Idler Pulley 532 0294 10 Change of Material

LuK AS Part No.: **532 0294 10**

INA 0019

Fig. 1: 532 0294 10 (old Version)

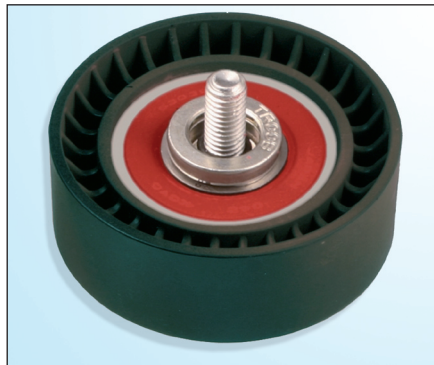
As part of the ongoing development of our products, we have changed the bearing surface of idler pulley **532 0294 10** from plastic to metal.

During the transition phase therefore it is possible that idler pulleys with plastic or metal rollers will be shipped.

Despite their different versions, both idler pulleys are fully compatible with the vehicles indicated in the catalogue.
